**Item 6.****Development Application: 905 South Dowling Street, Zetland - D/2024/1055****File Number:** D/2024/1055**Summary****Date of Submission:** 21 November 2024

**Proposal Summary:** Approval is sought for a mixed-use development on the Southern (S) stage of the broader Suttons redevelopment site comprising:

Figure 15: Building S2 ground floor plan

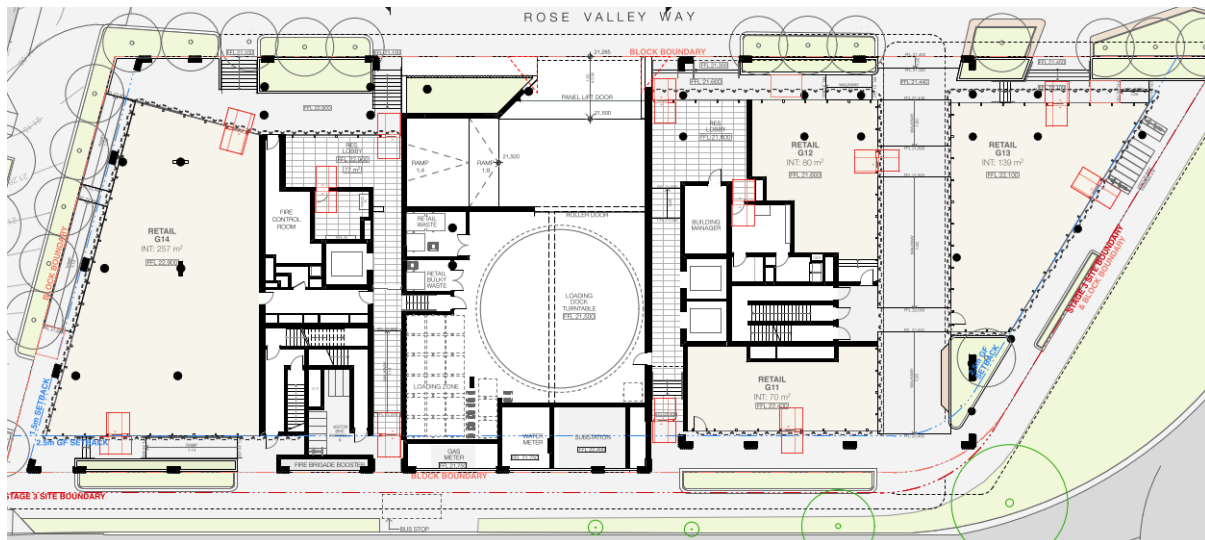
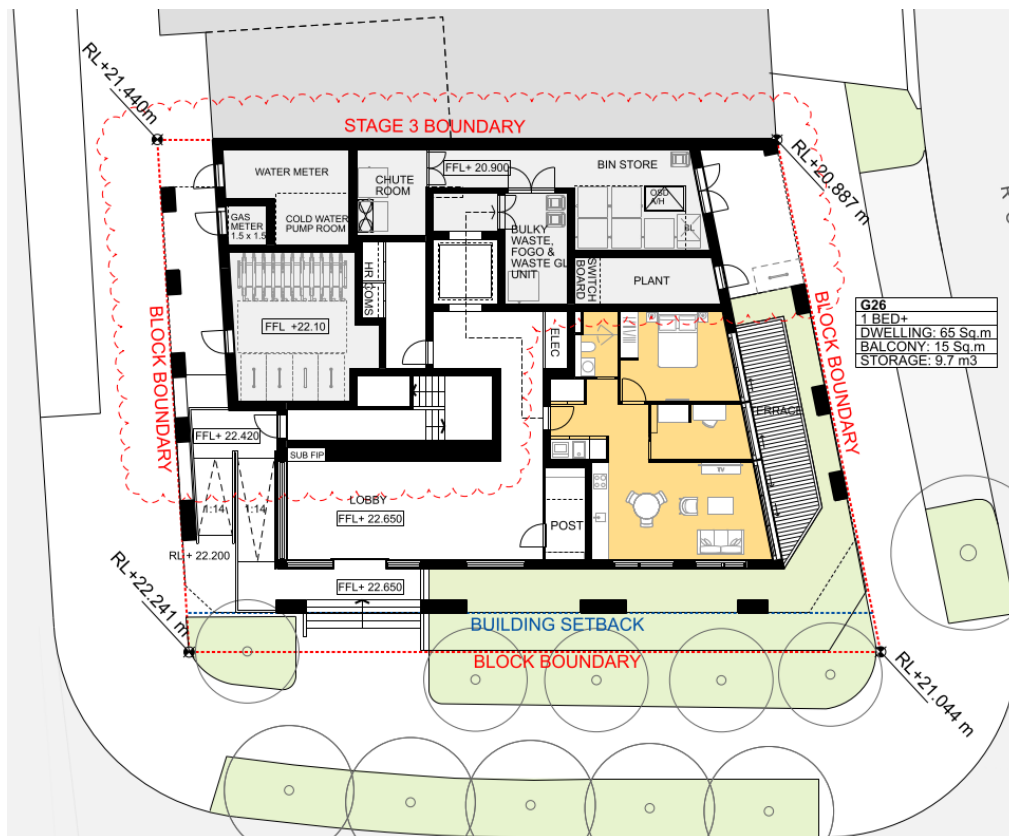
81. The applicant made some minor amendments to the Building S2 ground floor plane, however, issues remain, including the lack of coordination between the building columns, external pathways and the shopfronts. There are level changes across the site and a number of stairs are proposed. A design modification condition is recommended that required improved design resolution which will address access and ensure high quality interface with the public domain.

82. The site is subject to a 2.5m ground floor setback in accordance with the concept approval. Services along the Epsom Road frontage have been proposed with a nil setback. To ensure that the services are not prominent within the Epsom Road streetscape a design modification condition is recommended that extends the retail tenancies towards Epsom Road. A modification to the ground floor setbacks in the concurrent modification application to the Concept DA will ensure consistency between the detailed design DA and the Concept DA.
